**LANCASHIRE CENTRAL
RESPONSE TO LANDSCAPING COMMENTS**

Design Code

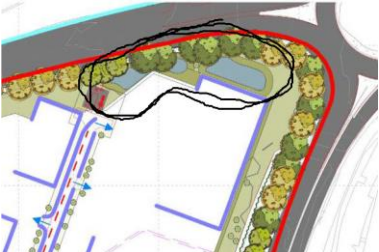
Comment	Response
<p>The location of the car parks that serve the large buildings near the main roundabout in the screenshot above and below is a concern:</p>  <p>This type of layout effectively places a huge 'core' of car parking (bounded by the black line above) right at the centre of Zone A making it the dominant design/visual feature. Locating them to the front of the buildings they serve and around the roundabout and connecting roads would provide those arriving via the site's main gateway off the M65 with views in all directions of large areas of bitmac surfacing/vehicles which is at odds with the design code's stated aim of "providing a strong and dynamic gateway entrance to the site." Unfortunately, and as explained above, since the design code fails to provide information on the applicant's options appraisal, area use selection criteria, building location, etc. the thinking behind locating car parks in front of buildings close to link roads rather than behind as is the case for service yards is not known. Whatever the reason(s), it has to be said that the proposed location of the main car parks is sub-optimal in landscape and visual terms and is really more suited to an industrial area where visual receptor sensitivity is much lower and functional requirements are different.</p>	<p>Whilst these comments are noted they relate to the layout of the Illustrative Development Framework and parts of the Site which the Applicant is only seeking outline planning permission for at this stage. Clarification on this point has been made via the February 2023 revision to the Design Code, which uses the Parameter Plans as a base map, and omit reference to the illustrative layout. As such these comments should carry no weight in the determination of this application.</p> <p>Notwithstanding this point, it is considered appropriate to place car parking and functional servicing areas in these locations, as they will be located behind the strategic landscaping which runs alongside the link road. The aim of the landscaping should be to enhance the setting and character of the business park, not to screen it from view. Every effort will be made through the design process to provide clear and legible approaches to each building, and to ensure that the landscaping enhances these linkages.</p>

Parameter Plan 3 – Strategic Landscape

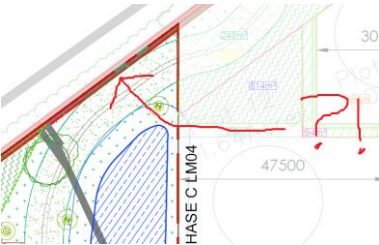
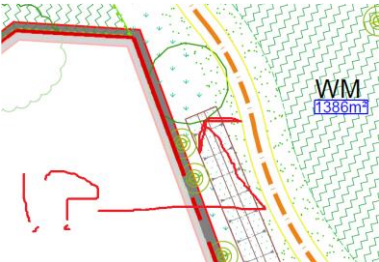
Comment	Response
<p>This plan is of little use as it has no key for the proposed strategic landscaping. As a minimum this parameters plan should provide clear</p>	<p>Parameter Plan 3 is intended to provide an illustrative overview of the proposed strategic landscaping. The drawing is particularly important</p>

Landscape Proposals – Green Infrastructure A

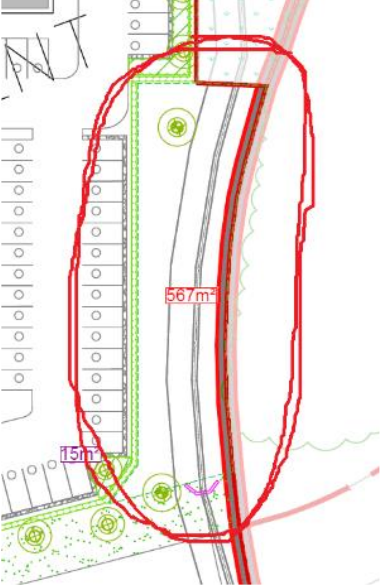
<p>As can be seen in the examples below (note, not an exhaustive list), excavation and other works are proposed within the root protection areas of existing trees and hedgerows intended for retention.</p> <p>Tree directly in the path of a proposed SUD (swale?):</p>	<p>The tree protection fence would be positioned 2m from base of hedge to allow retention.</p> <p>The tree in the line of SuDs feature is a drawing error which shows an existing tree which is scheduled for removal. The loss is mitigated</p>

Comment	Response
 <p>SUD within hedgerow root protection area (RPA):</p>	<p>through the planting of replacement trees in the area, and the public benefits of the SUD design.</p>
 <p>Excavation within tree RPA:</p>	<p>The most up-to-date drawings (Rev E) show the excavation adjusted to be outside of the RPA of this tree.</p>
 <p>Proposed planting within RPA of plants within private land:</p>	<p>The proposed planting within the RPA of the off-site tree has been omitted in the most up-to-date drawings (Rev E)</p>

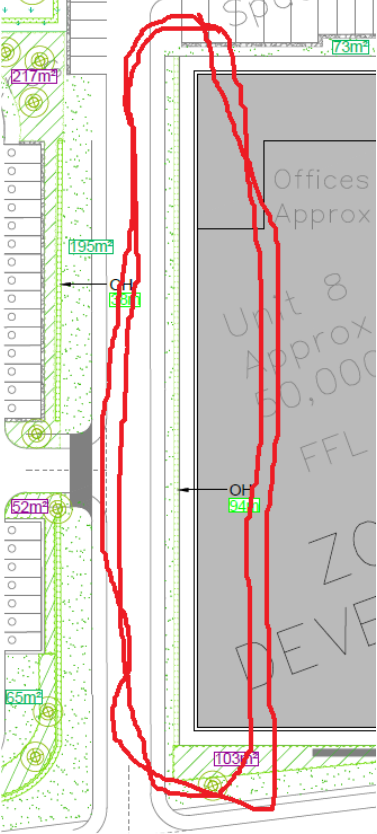
<p>As the trees in the highlighted area below would be planted directly on the site boundary, their canopies at maturity would overhang adjacent land. In addition, as the trees matured any boundary fencing</p>	<p>The neighbouring land comprises an area of rough ground behind a farmstead and compatible with proposals.</p>

Comment	Response
<p>could be damaged by canopy branches and/or expansion of the root plate.</p> 	
<p>Even though only one is shown in the drawing key, as can be seen in the areas highlighted in red below, two different hatches have been used for the SUD's:</p> 	<p>Corrected in current drawing SF 3236 LL04 Rev J.</p>

Landscape Proposals – Phase A

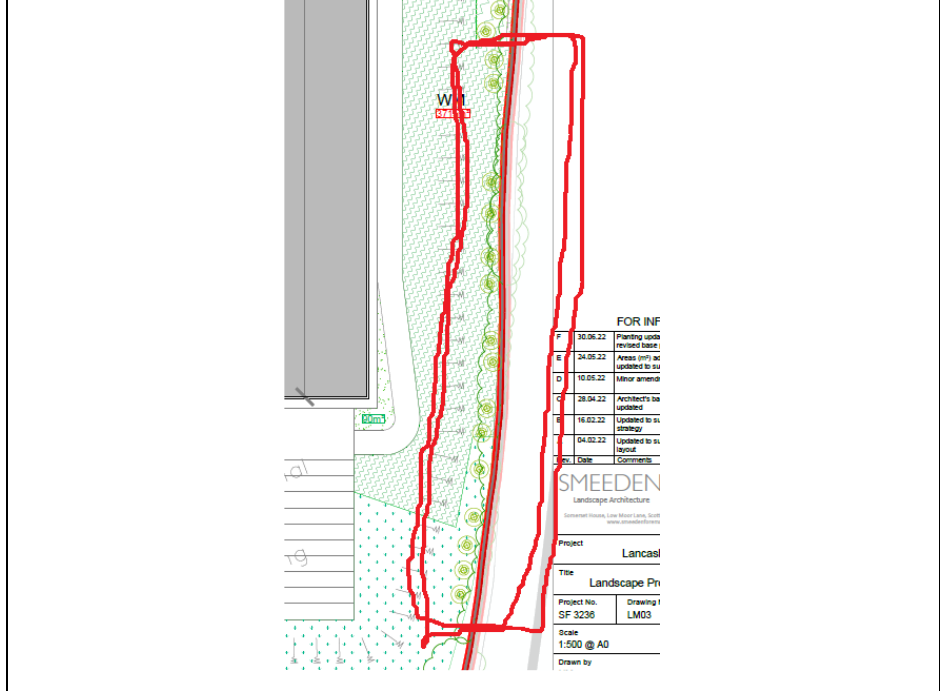
<p>Generally, the proposed mitigation planting around the larger structures is inadequate. In many cases the proposed ornamental hedges would be dwarfed by the large industrial structures exacerbating their discordant scale in the landscape. Here are some examples:</p> 	<p>These comments relate to the illustrative part of the drawings. The layout and landscaping proposals within this area is reserved for future consideration and would be subject to a separate application.</p>

Landscape Proposals – Phase B

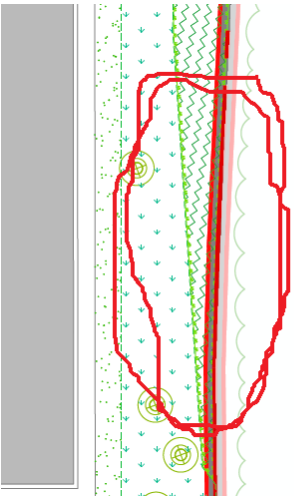
<p>Tree and woodland planting are proposed along the Wigan Road frontage which includes heavy standard trees, presumably to provide immediate mitigating effect during the opening year. As can be seen in the screenshot below, some of these heavy standard trees would be planted far too close to Wigan Road:</p>	<p>These trees are planted to the rear of proposed and existing hedgerows and will not have an adverse impact upon Wigan Road.</p>

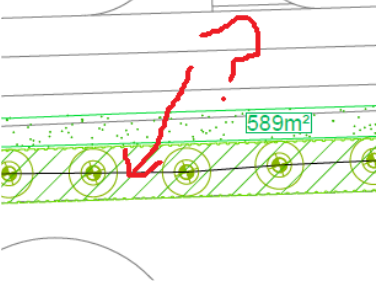
<p>The grassed area sandwiched between existing hedgerow and proposed 'woodland' serves no purpose. The woodland planting would provide more effective mitigation if it was located adjacent to the site boundary and the grassland was relocated to where the woodland is shown below:</p> 	<p>These comments relate to the illustrative part of the drawings. The layout and landscaping proposals within this area is reserved for future consideration and would be subject to a separate application.</p> <p>This arrangement has ecological value and avoids planting the woodland over the top of a surface water drainage route</p>
<p>Unlike most of the proposed planting areas within the scheme, the two important areas of screen planting highlighted by the red outlines below would have no heavy standard or extra heavy standard trees. These trees are crucial for providing immediate impact in the opening year:</p>	<p>These comments relate to the illustrative part of the drawings. The layout and landscaping proposals within this area is reserved for future consideration and would be subject to a separate application.</p>

Comment	Response
	<p>There is existing vegetation on the edge of the site taller than any larger nursery stock that might be introduced into this area.</p>
<p>The area outlined in red below is far too narrow for 'woodland' planting or creation:</p> 	<p>These comments relate to the illustrative part of the drawings. The layout and landscaping proposals within this area is reserved for future consideration and would be subject to a separate application.</p>
<p>The landscaped areas along the frontage of these access roads are too narrow for planting to achieve any meaningful mitigating effect. They also fail to maintain the applicant's 'boulevard' concept for the main access roads:</p> 	<p>These comments relate to the illustrative part of the drawings. The layout and landscaping proposals within this area is reserved for future consideration and would be subject to a separate application.</p>

Landscape Proposals – Phase D

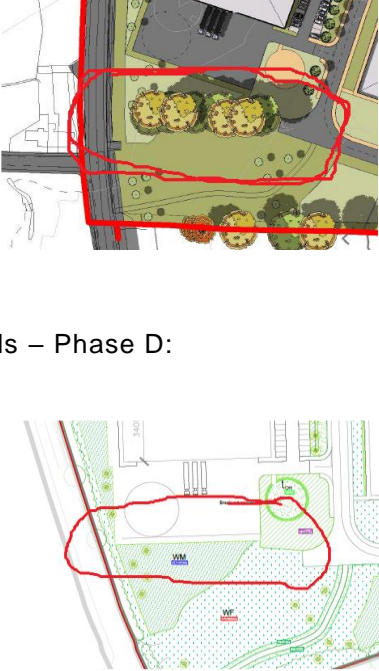
<p>The location of the proposed large building leaves no space in the area highlighted below for any effective mitigation planting. The proposed ornamental hedge which would be dwarfed by the adjacent large industrial building would do little other than highlight the inadequacy of the mitigation provided:</p>	<p>These comments relate to the illustrative part of the drawings. The layout and landscaping proposals within this area is reserved for future consideration and would be subject to a separate application.</p>
